A. DESCRIPTION OF THE PROPOSED CHANGE

This proposed amendment will revise Technical Specification Figures 3.1-3 and 3.1-4. These figures provide regulating group Control Element Assembly (CEA) insertion limits. Figure 3.1-3 provides CEA insertion limits when the Core Operating Limit Supervisory System (COLSS) is in service and Figure 3.1-4 provides the insertion limits when COLSS is out of service. The following two changes are proposed:

This proposed amendment will revise Technical Specification Figure 3.2-1A. This figure provides azimuthal power tilt limits versus core power for COLSS in service. The azimuthal power tilt limit will be increased for operation below 40% of rated thermal power.

This proposed amendment will revise Technical Specification Figures 3.2-2 and 3.2-2A. These figures provide DNBR margin limits for various configurations of COLSS and CEACs inoperable. The changes are necessary to ensure that the Technical Specifications are consistent with the safety analyses performed for the Cycle 3 core design.

FIGURE 3.1-3

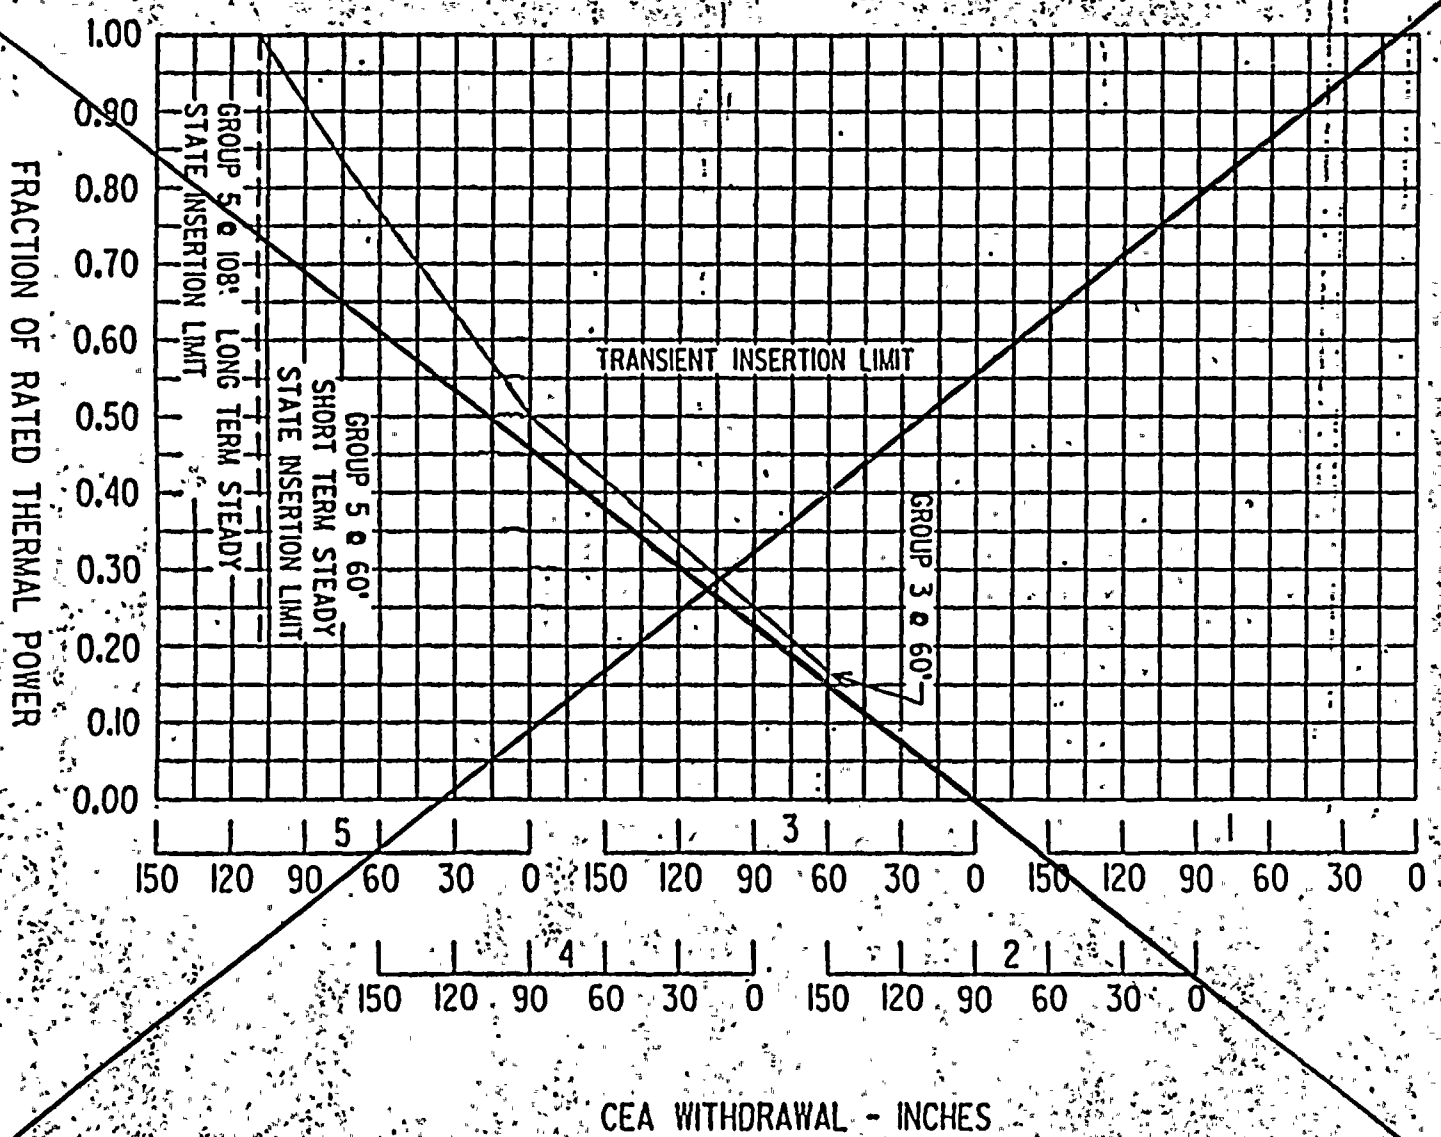
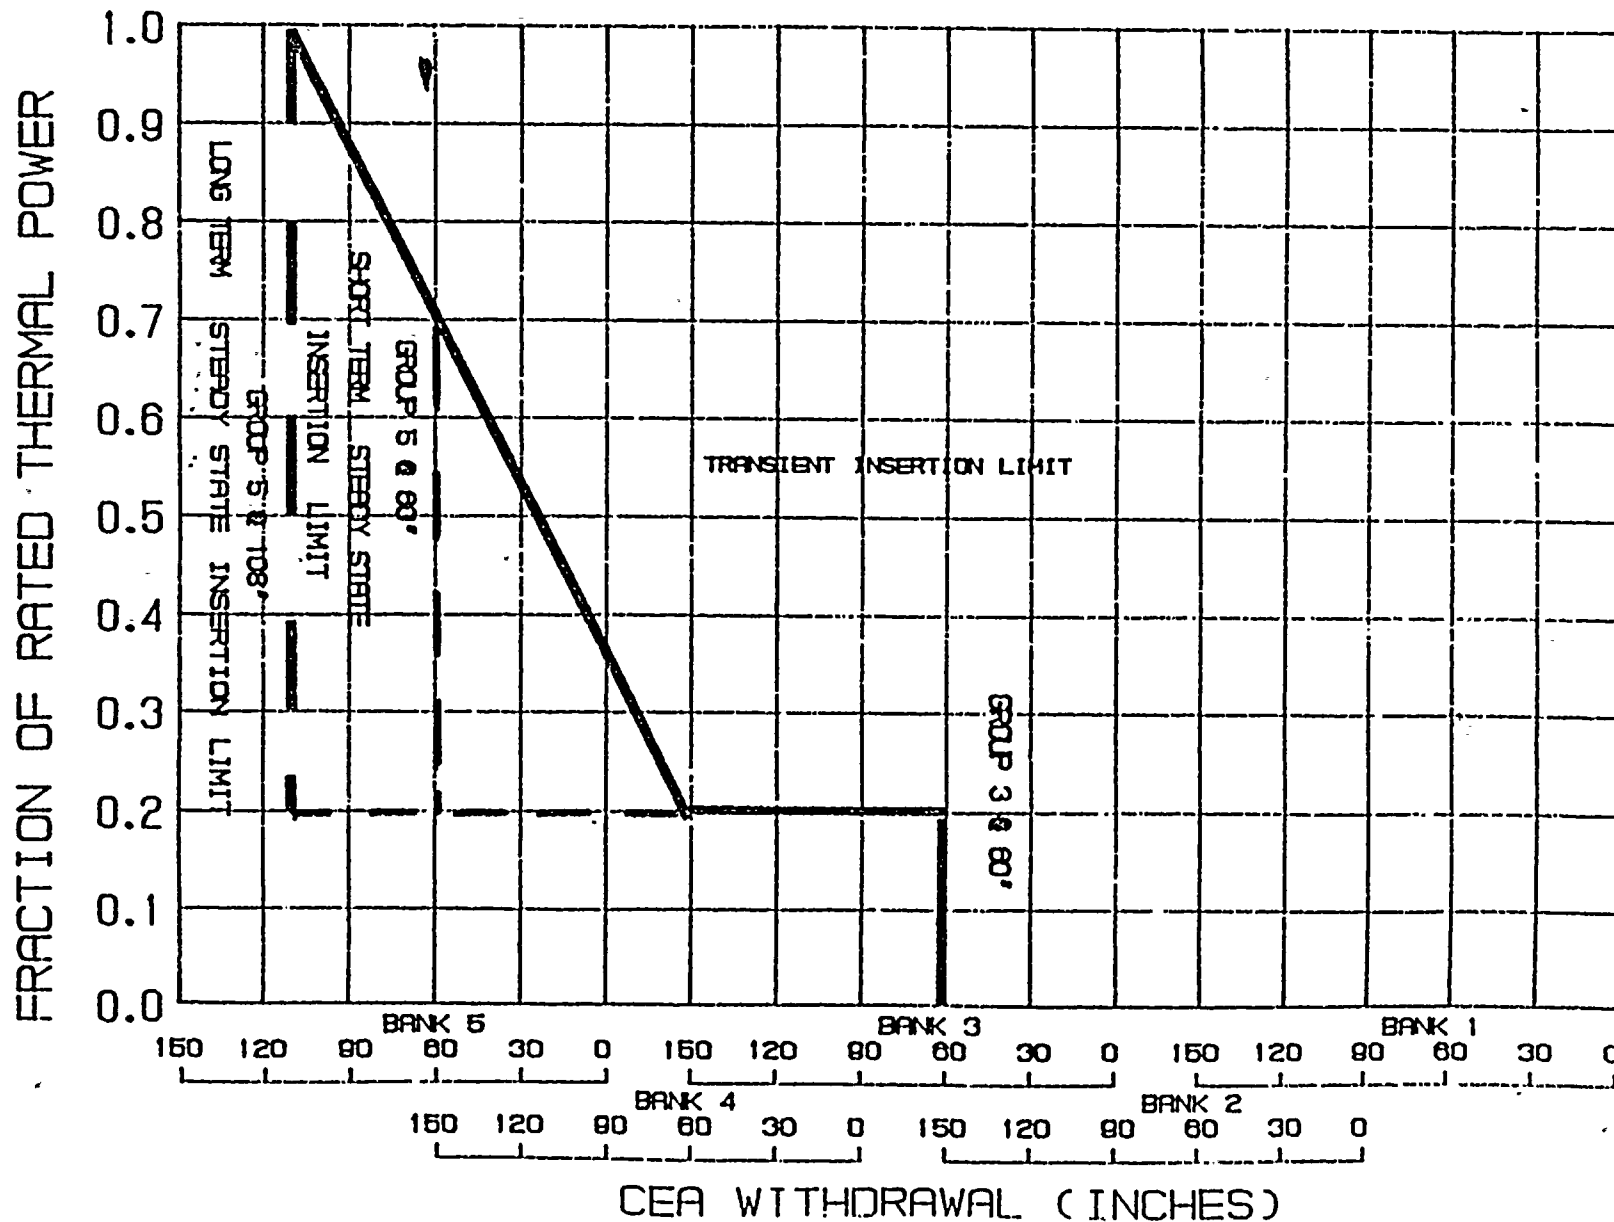
- i) The revised Figure 3.1-3 (COLSS in service) will not permit insertion of regulating group 3 CEAs above 20% of rated thermal power. This is more restrictive than the current specification which does allow for regulating group 3 insertion above 20% of rated thermal power.
- ii) The revised Figure 3.1-4 (COLSS out of service) will permit slightly increased insertion of regulating group 3 CEAs between 15% and 20% of rated thermal power.

REPLACE WITH
NEW FIGURE 3.1-3

The proposed changes to the transient insertion limits are necessary to ensure that the Technical Specifications are consistent with the safety analyses performed for the Cycle 3 core design. A more restrictive transient insertion limit line is required when COLSS is in service and a slightly less restrictive limit is allowed when COLSS is out of service.

The proposed revisions to Technical Specification Figures 3.1-3 and 3.1-4 will not increase the probability or consequences of any accidents previously evaluated in the FSAR. The transient insertion limits of Figure 3.1-3 will become more restrictive by not permitting regulating group 3 insertion above 20% power. The revised Figure 3.1-4 will permit slightly increased insertion of regulating group 3 between 15% and 20% power. These changes are consistent with the Cycle 3 safety analyses. The probability and/or consequences of an accident previously evaluated in the FSAR will not be increased because the results of the Cycle 3 safety analyses, using the revised CEA insertion limits of Figures 3.1-3 and 3.1-4, assure that there is sufficient margin for the most limiting DBE. The analyses performed included an evaluation of all safety analysis events for which the CEA insertion limit curves serve as an initial condition. Therefore, the probability or consequences of an accident previously evaluated in the FSAR will not be increased.
